Preliminary Drainage Report
for
Windingwalk Filings 1 & 2 PUD
and
Final Drainage Report
for
Windingwalk Filing 1
at
Meridian Ranch

March 2018

PCD Project No. PUDSP-18-002
SF-18-002

STAPLETON DRIVE BOX CULVERT PROFILE

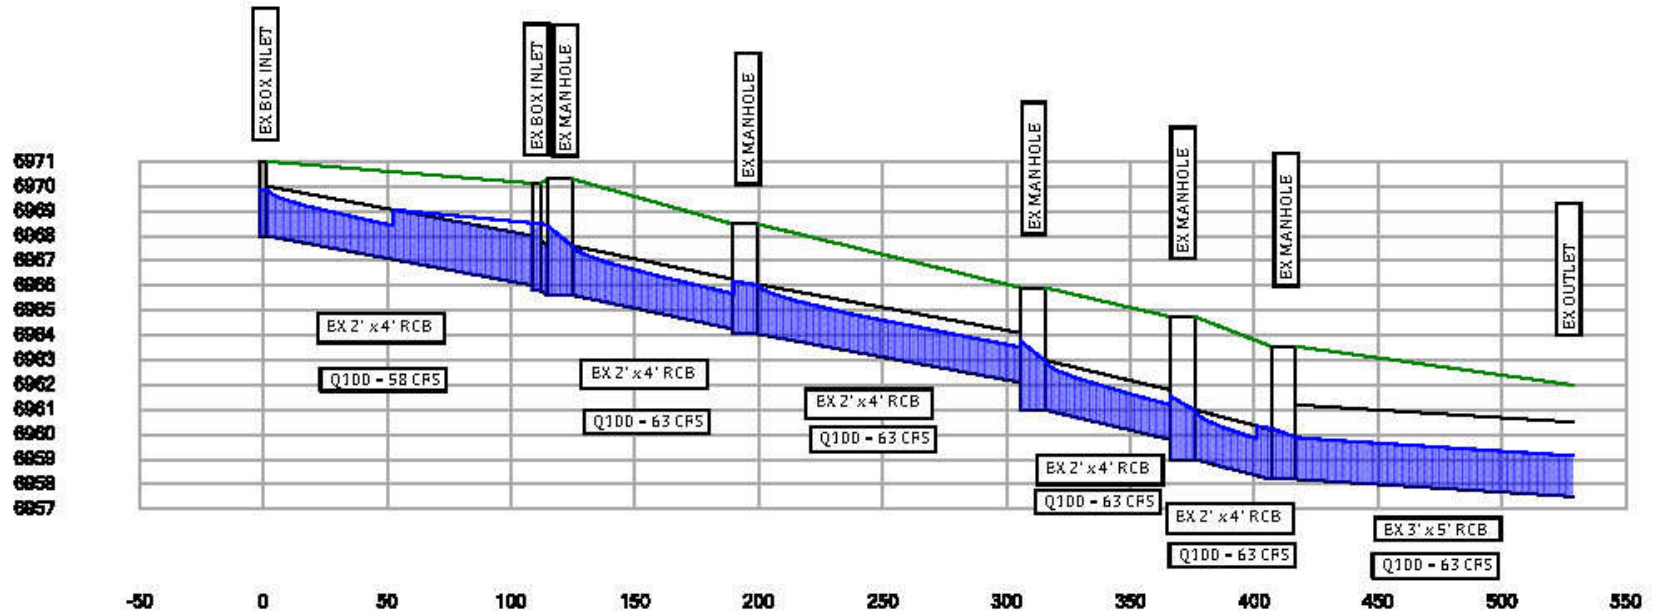
Provide an exhibit identifying the locations for each of the Stapleton Channel sections.

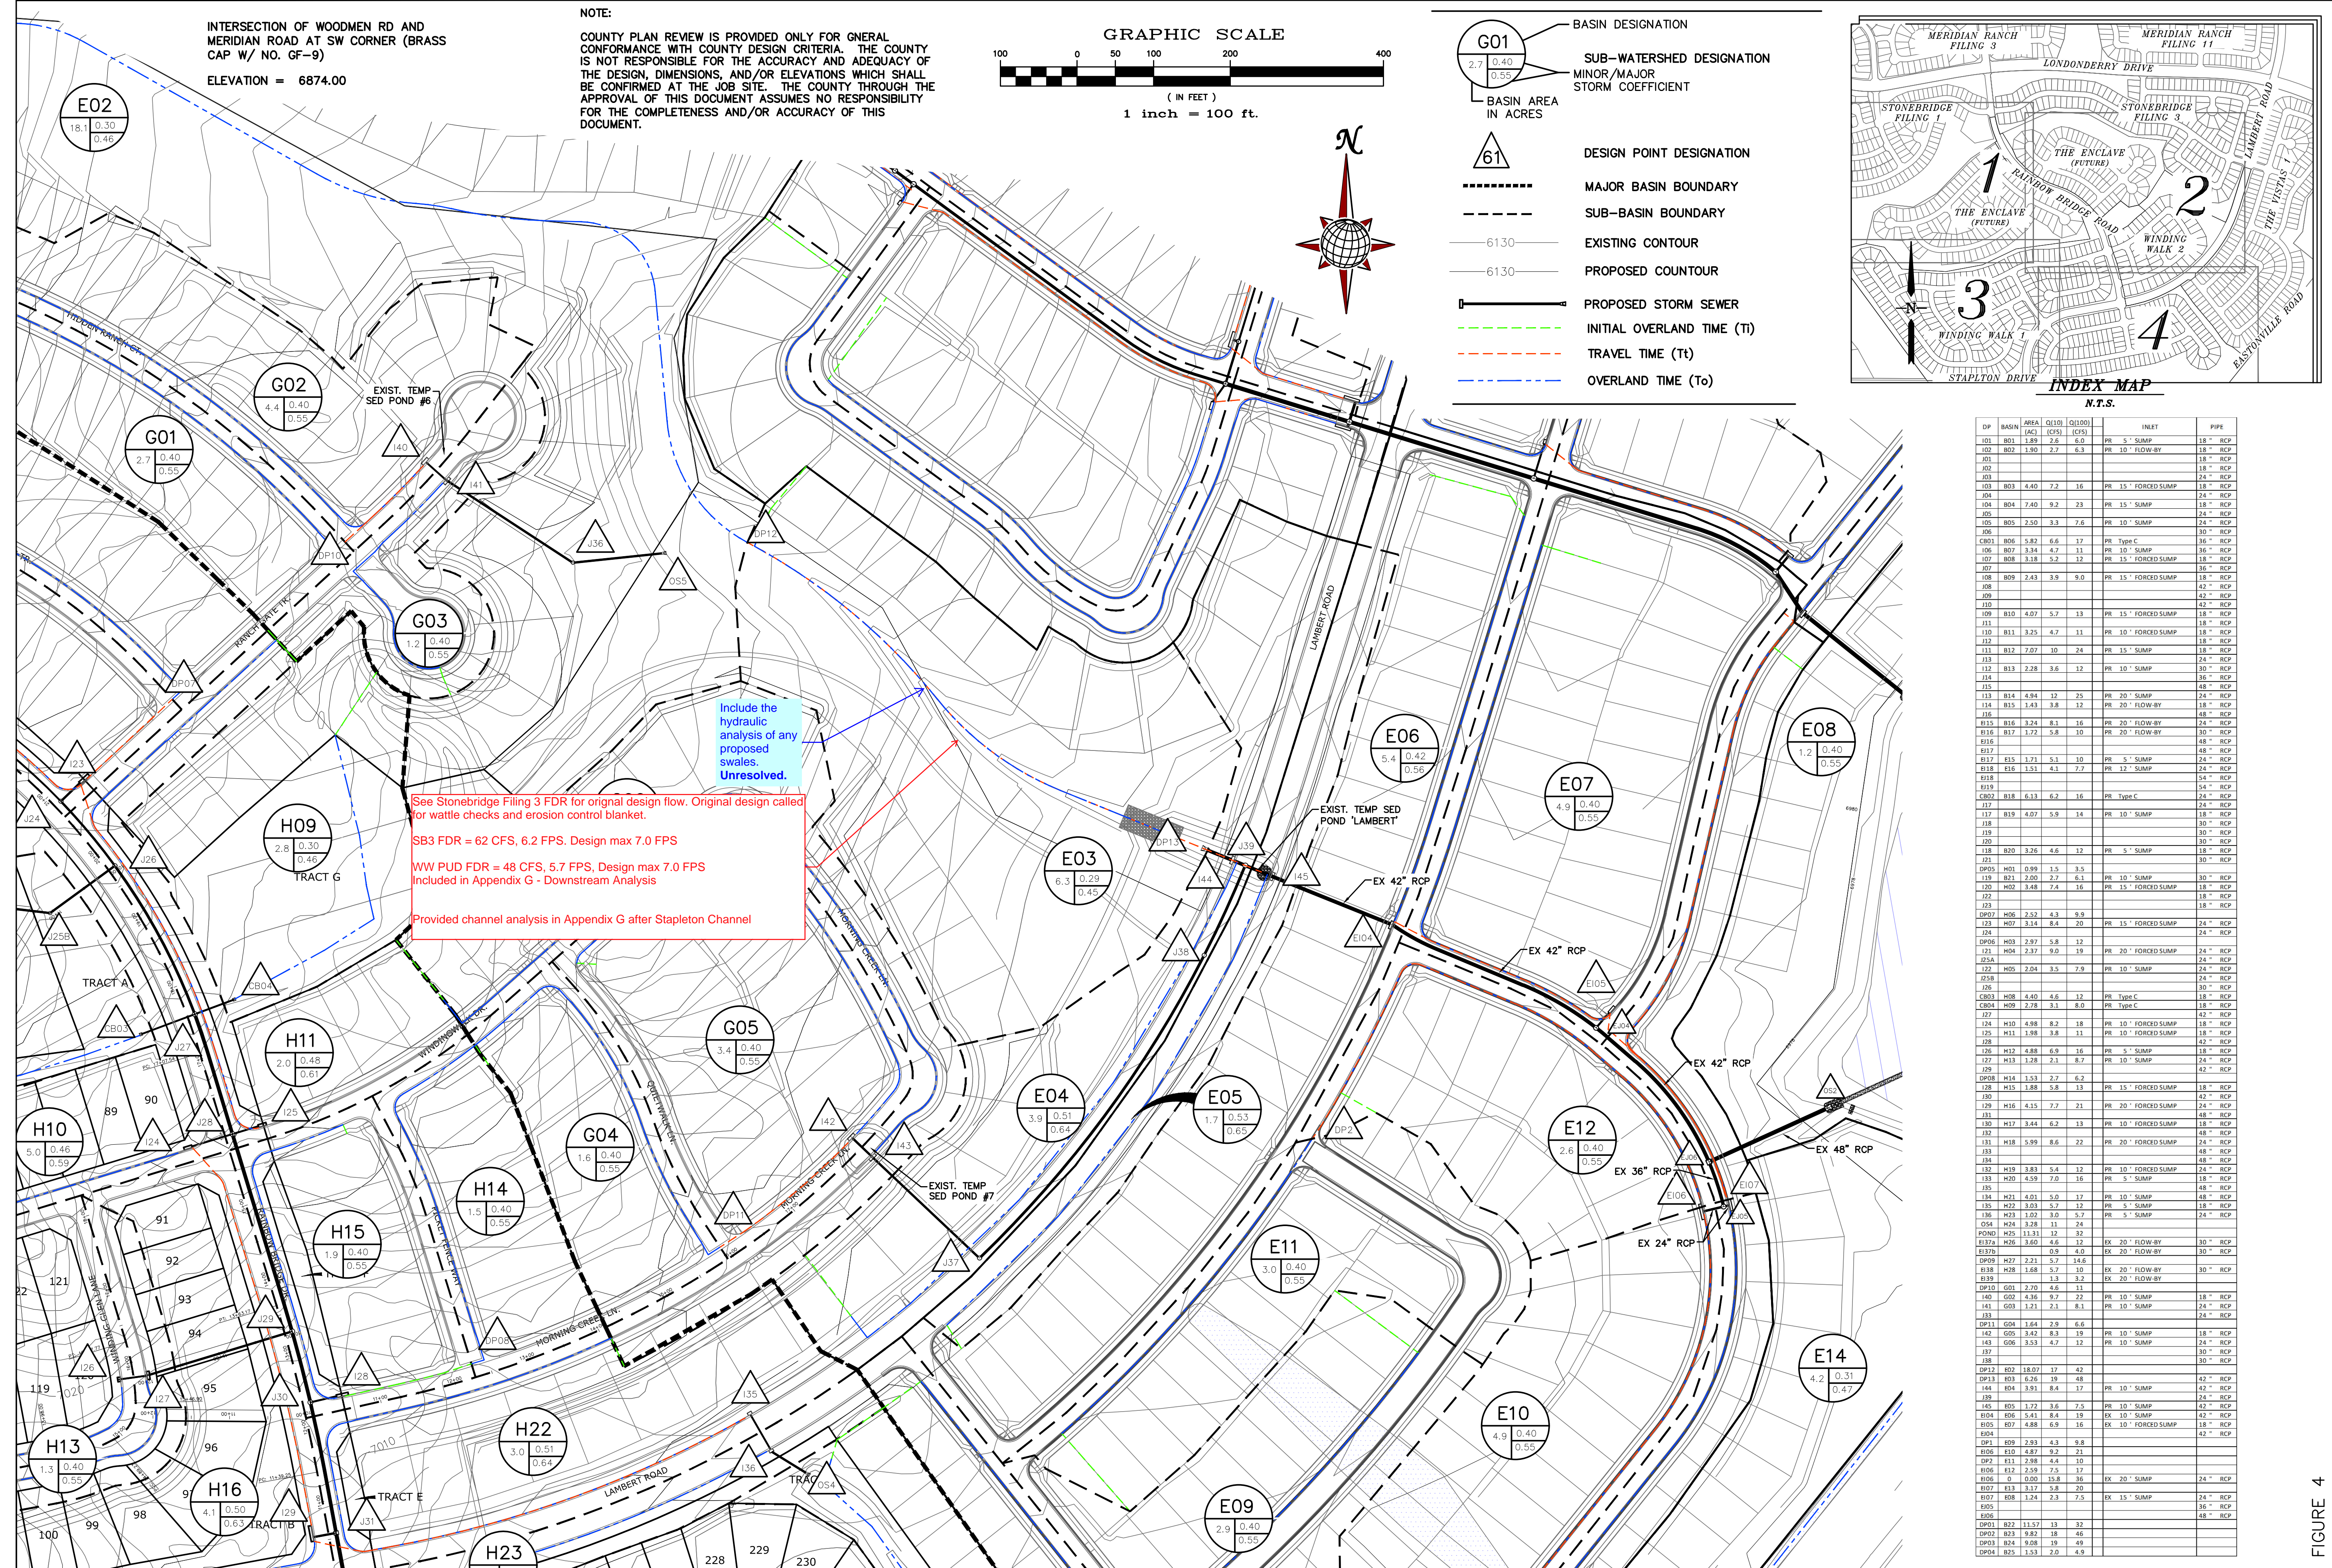
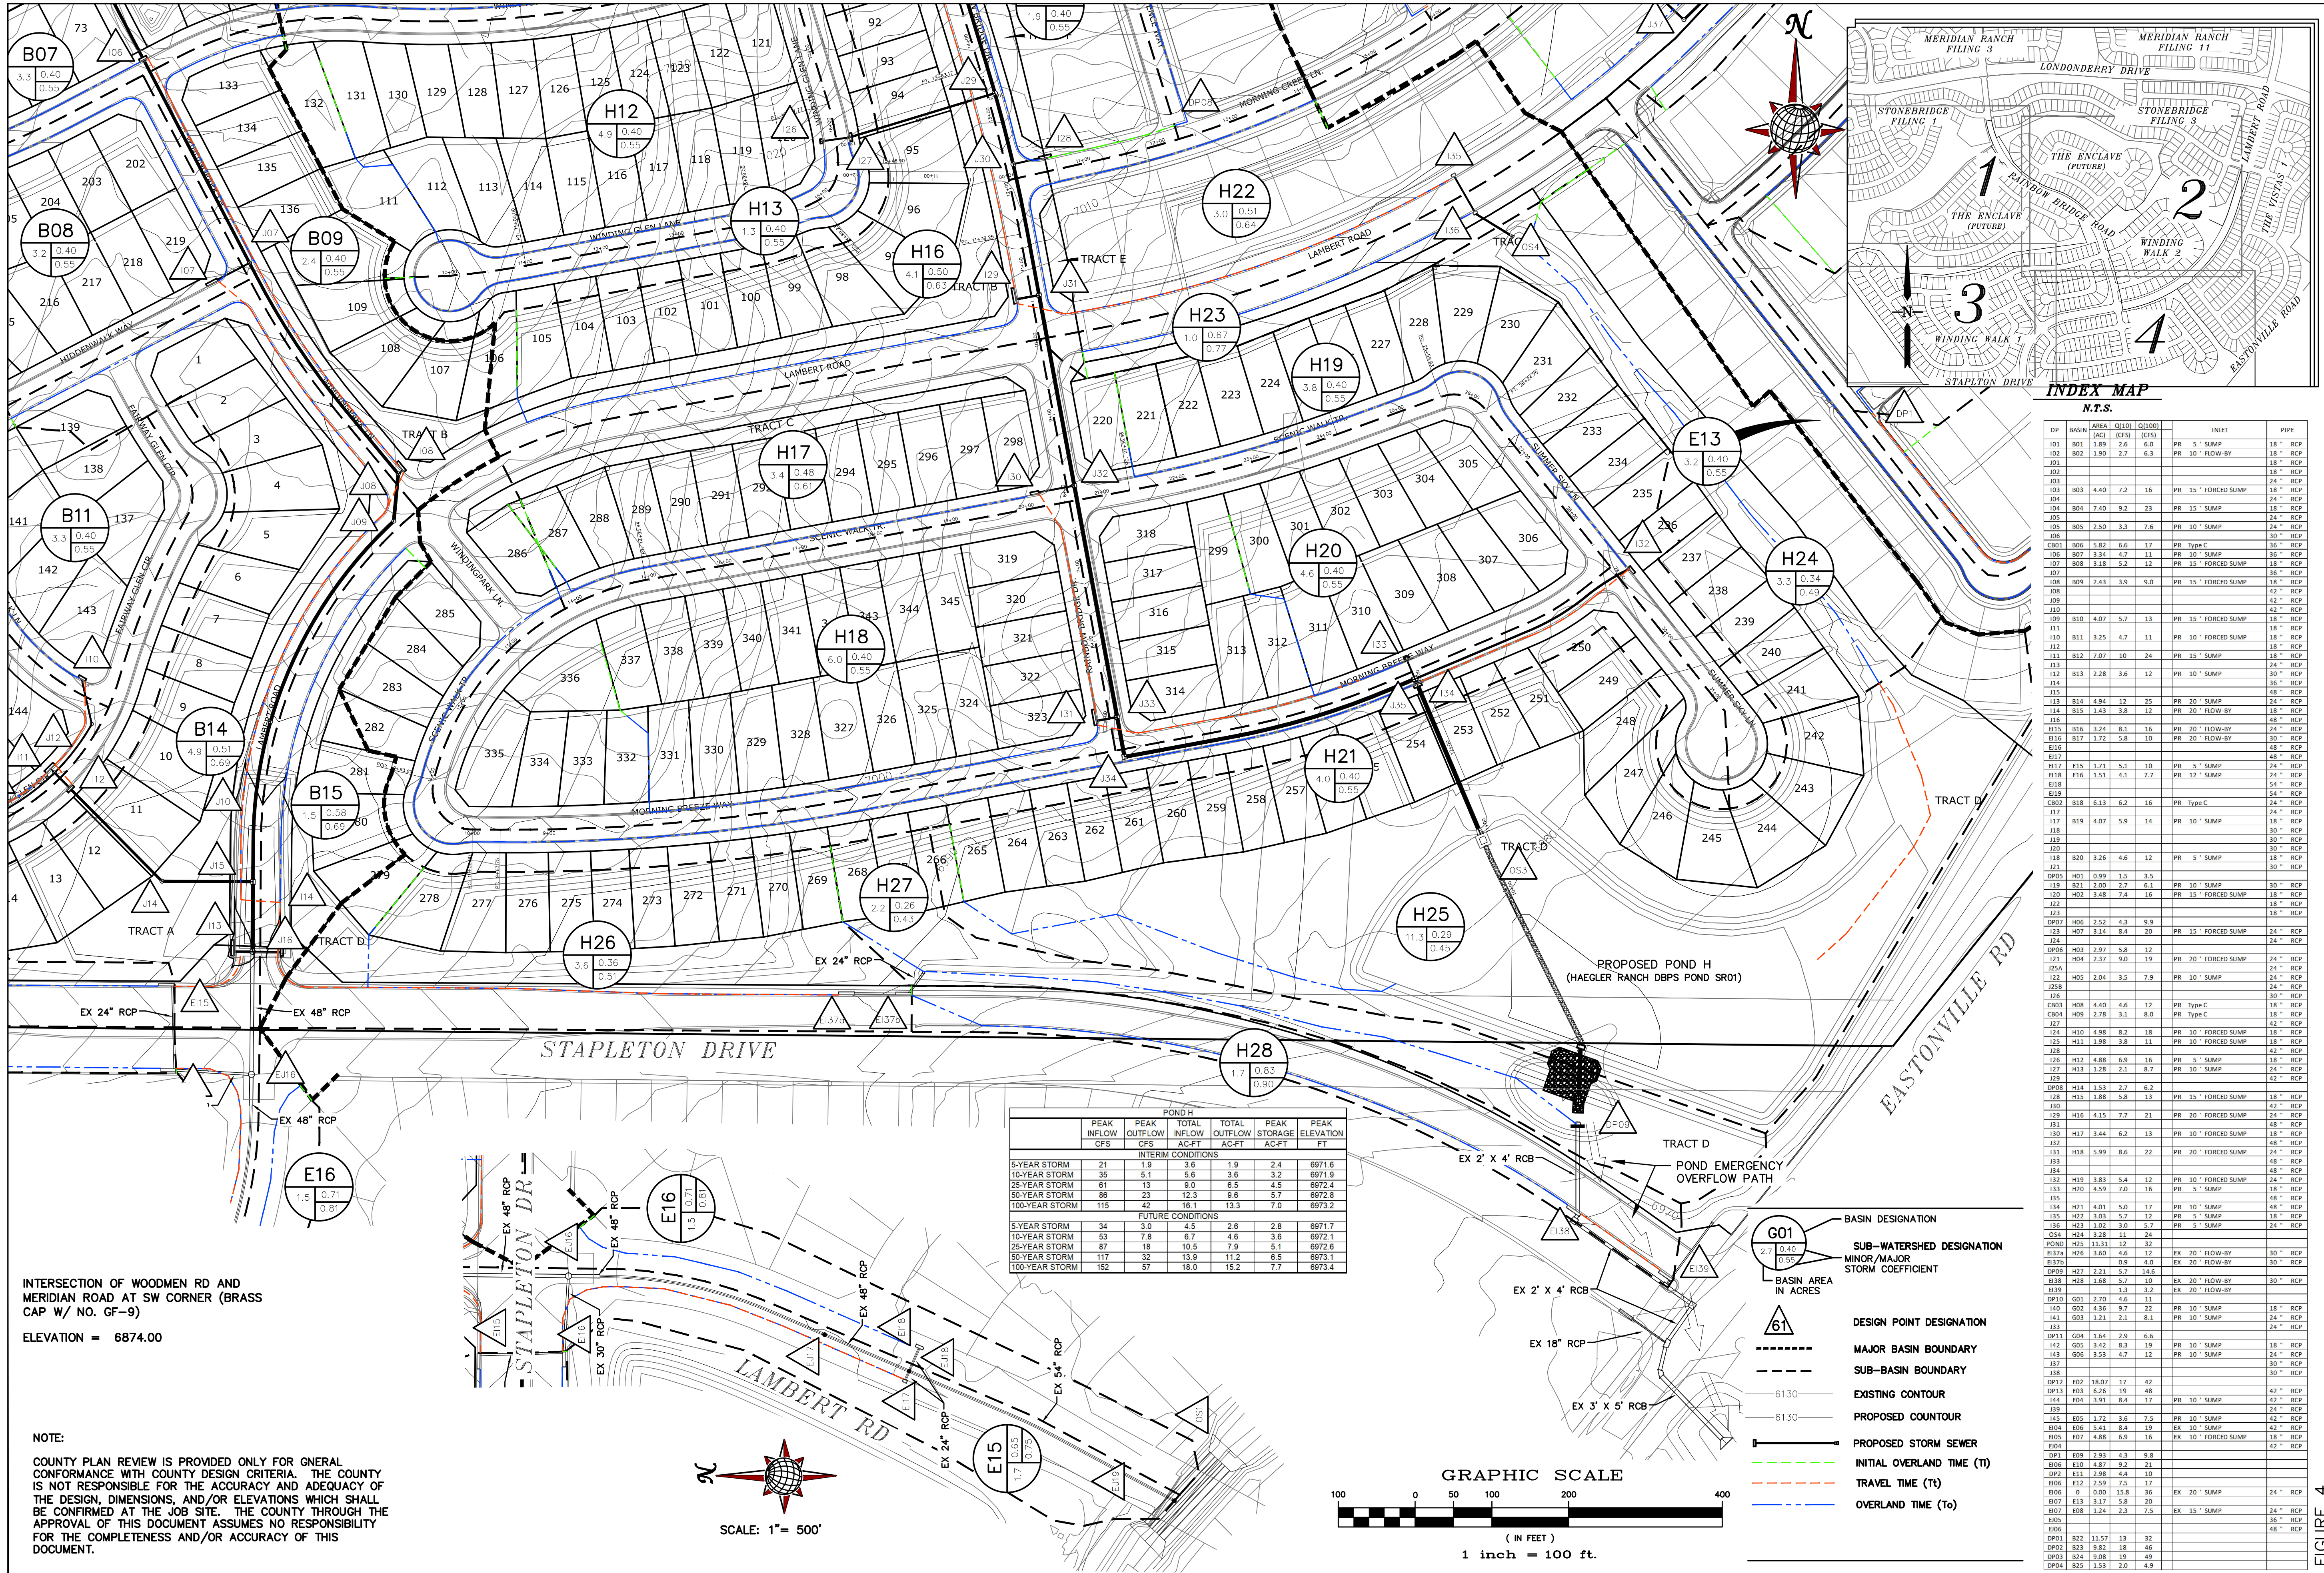
See Stonebridge Filing 3 FDR for original design flow. Original design called for wattle checks and erosion control blanket.
SB3 FDR = 62 CFS, 6.2 FPS. Design max 7.0 FPS
WW PUD FDR = 48 CFS, 5.7 FPS. Design max 7.0 FPS
Included in Appendix G - Downstream Analysis
Provided channel analysis in Appendix G after Stapleton Channel
